Office Action Summary

10/568,980

FUJIOKA ET AL.

DETAILED ACTION

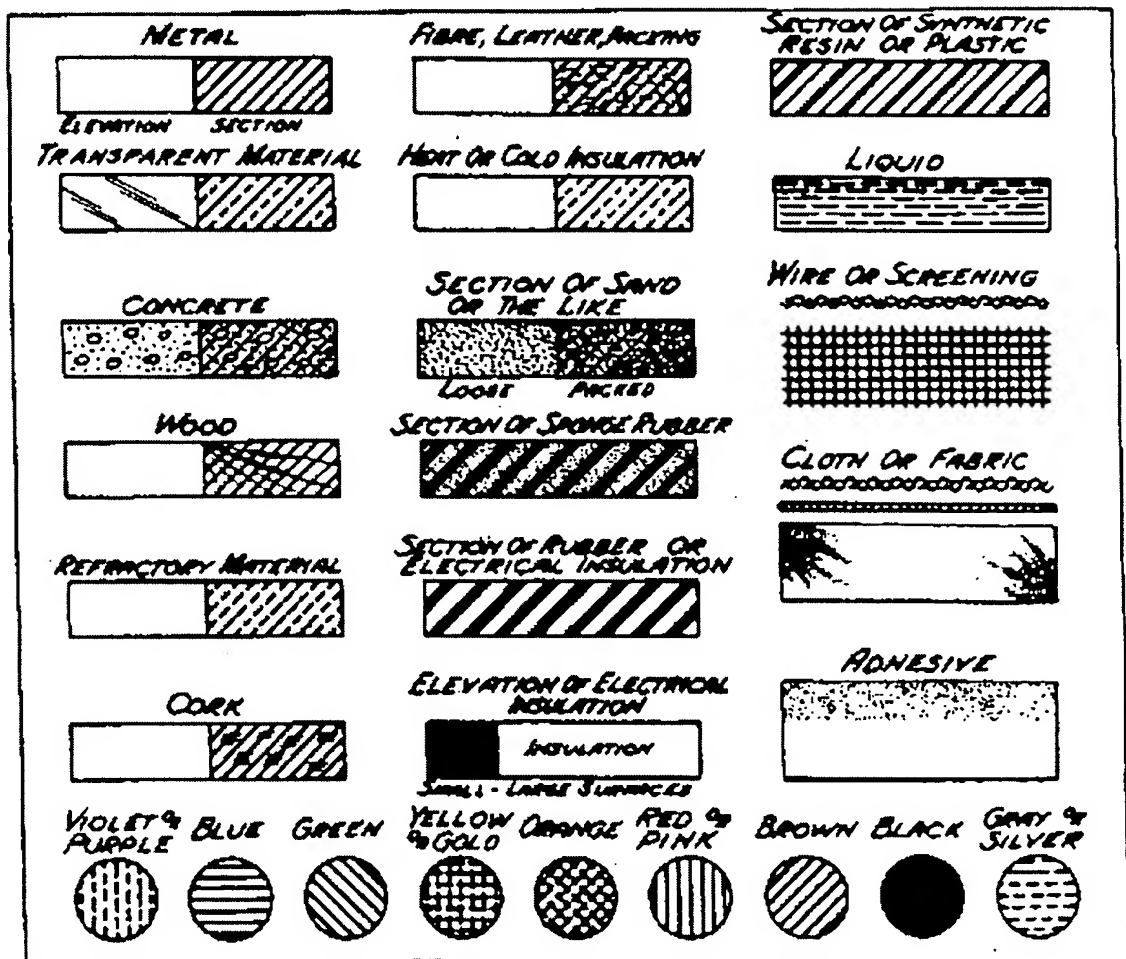
2. The drawings are objected to because the cross-section elements are not cross-hatched. Corrected drawing sheets in compliance with 37 CFR 1.121(d) are required in reply to the Office action to avoid abandonment of the application. Any amended replacement drawing sheet should include all of the figures appearing on the immediate prior version of the sheet, even if only one figure is being amended. The figure or figure number of an amended drawing should not be labeled as "amended." If a drawing figure is to be canceled, the appropriate figure must be removed from the replacement sheet, and where necessary, the remaining figures must be renumbered and appropriate changes made to the brief description of the several views of the drawings for consistency. Additional replacement sheets may be necessary to show the renumbering of the remaining figures. Each drawing sheet submitted after the filing date of an application must be labeled in the top margin as either "Replacement Sheet" or "New Sheet" pursuant to 37 CFR 1.121(d). If the changes are not accepted by the examiner, the applicant will be notified and informed of any required corrective action in the next Office action. The objection to the drawings will not be held in abeyance.

The following hatching symbols should be used to indicate various materials where materials in cross-section. The use of such hatching is also very helpful in making prior art searches.
